**PLANNED UNIT DEVELOPMENT
& SUBDIVISION STAFF REPORT****Date: May 19, 2016****DEVELOPMENT NAME**

Paramount Center Subdivision

Planned Unit Development Approval to allow shared access and parking between multiple structures on multiple lots, and Subdivision approval to create 3 lots.

SITE PLAN

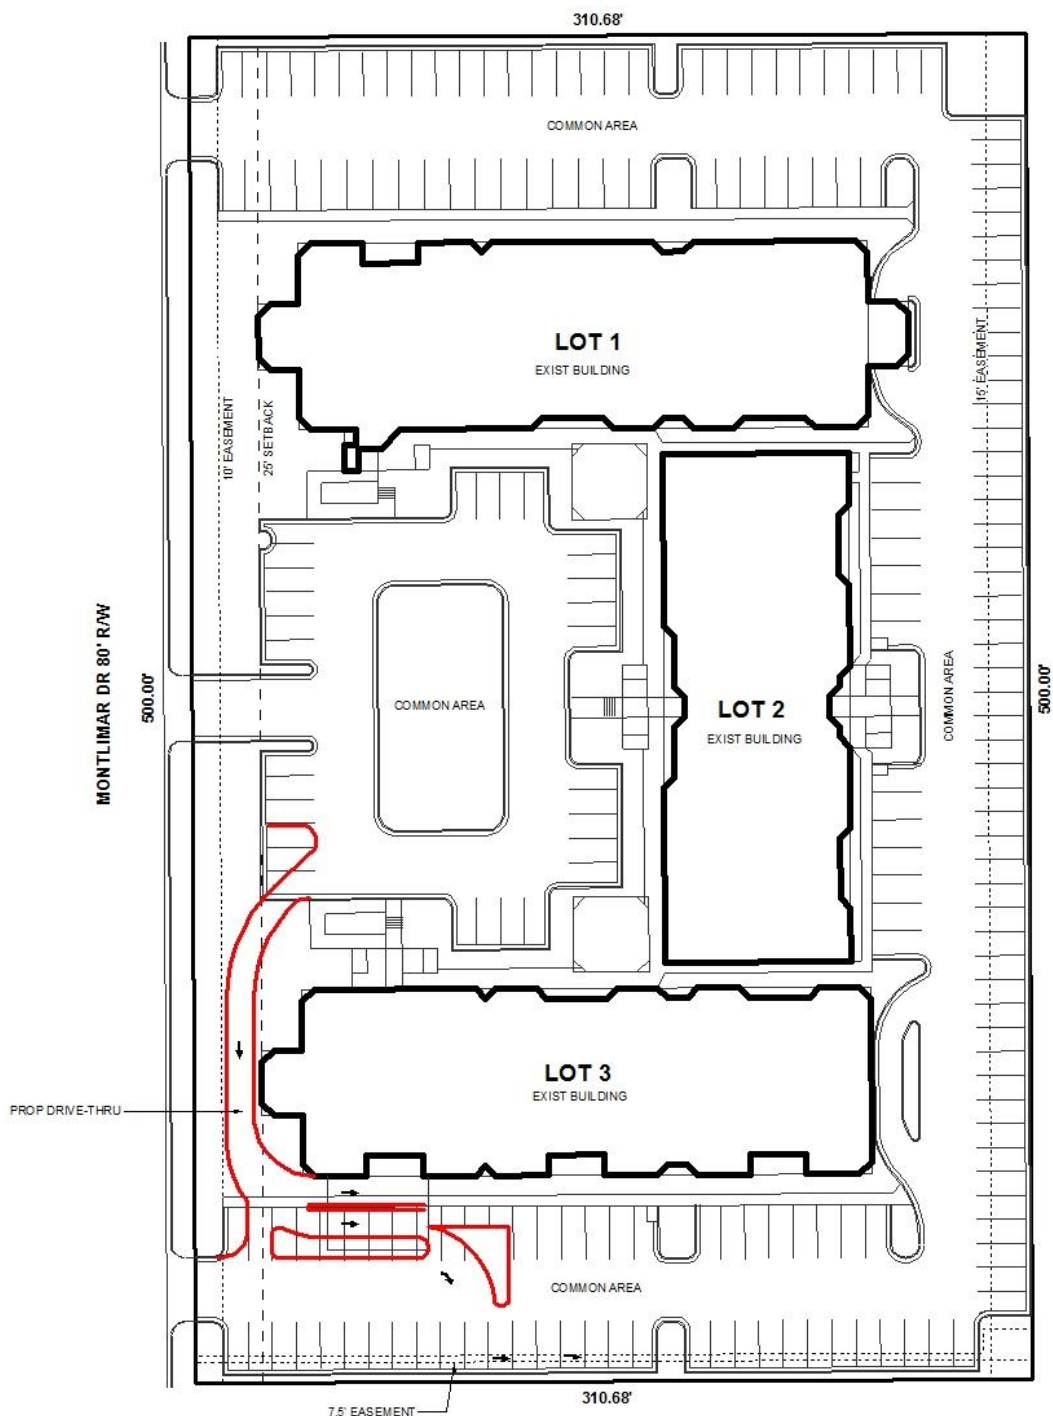
Each lot is limited to one curb cut, with size, location and design to be approved by Traffic Engineering and conform to AASHTO standards. On-site parking, including ADA handicap spaces, shall meet the minimum standards as defined in Section 64-6 of the City's Zoning Ordinance. PUD site plan should be revised to eliminate what appears to be an error in the drawing (duplicate island and right turn arrow).

No dumpster is depicted on the site plan, however, aerials show a dumpster on a pad and within an enclosure in the Northeast corner of the site. The site plan should be revised to reflect the existing dumpster facility.

While the site is developed, there is no sidewalk adjacent to the site along Montlimar Drive. Sidewalks exist on the properties immediately to the North and South, and along much of Montilimar Drive. The proposed addition of the drive-through and access drive, as well as the intent of the Map for Mobile, should spur consideration for the provision of a sidewalk along the entire frontage of the site along Montlimar Drive as part of the project.

The 25-foot minimum building setback depicted within the Common Area along Montlimar Drive, as well as all of the various drainage and utility easements on the site, should be retained on the Final Plat, if approved.

Finally, while not governed by the Subdivision Regulations or the Zoning Ordinance, it should be noted that no accessible parking spaces are depicted on the site plan. As the site is proposed to have approximately 190 parking spaces after completion of the drive-through project, a minimum of six (6) accessible parking spaces is required, of which one must be van accessible. Please refer to the 2012 International Building Code, the 2003 ICC/ANSI A117.1, and the Americans with Disabilities Act, for more information.

- 1) Revision of the site plan to depict a new sidewalk along the Montlimar Drive right-of-way, and construction of the sidewalk during the drive-through construction process, with applicable Right-of-Way permits;

- 2) Revision of the site plan to depict the existing dumpster enclosure area;
- 3) Compliance with Section 64-4.F. of the Zoning Ordinance regarding drive-through facilities;

- 4) Addition of a note and symbol to the site plan to show the by-pass drive as "exit only" in order to discourage incoming traffic from the southern-most entrance;

DETAIL SITE PLAN

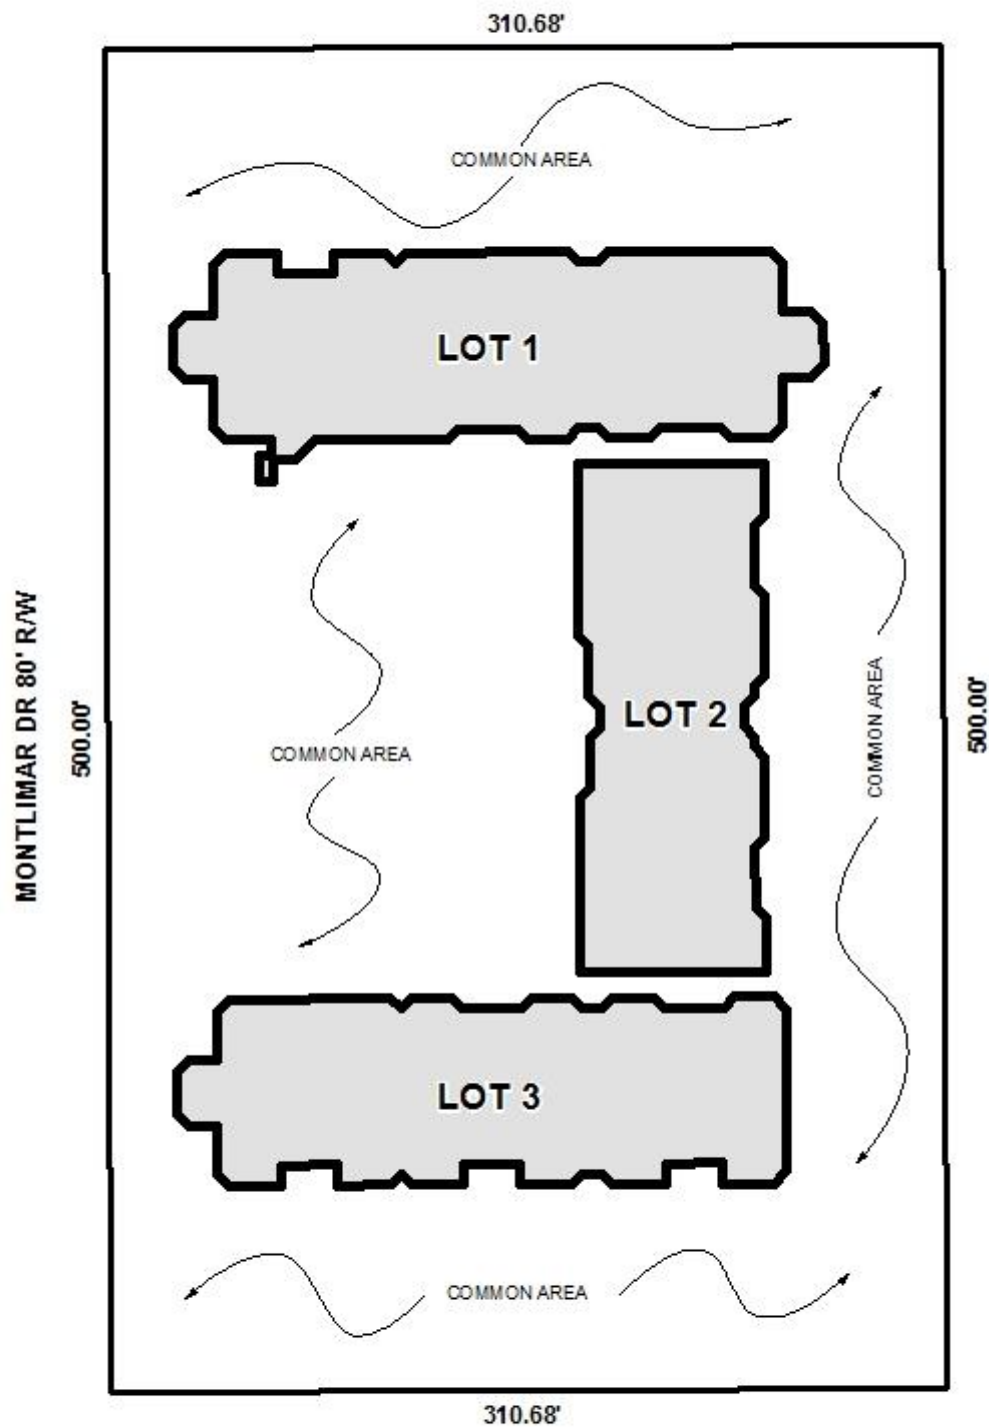
The site has three existing curb-cuts to Montlimar Drive, which serve two existing parking lots. The proposed drive-through will be accessed via an existing parking area located in the middle of the site, and will exit into the parking area located on the South side of the site. The new 10-foot wide access will be placed between the building and the Montilimar Drive right-of-way, approximately 11 feet from the right-of-way. A 9 to 10 foot wide access from the Southernmost parking area is also proposed, which would either allow traffic in the new drive access to by-pass the drive-through, or allow another point of entry into the drive-through: to prevent conflict, the by-pass drive should be marked as "exit only."

At least three queuing spaces will be provided in the access drive, and it appears that there will be sufficient room for one queuing space after the drive. The lane widths also appear to meet the 9-foot minimum width. Therefore, it appears that the drive-through will comply with Section 64-4.F. of the Zoning Ordinance regarding drive-through facilities.
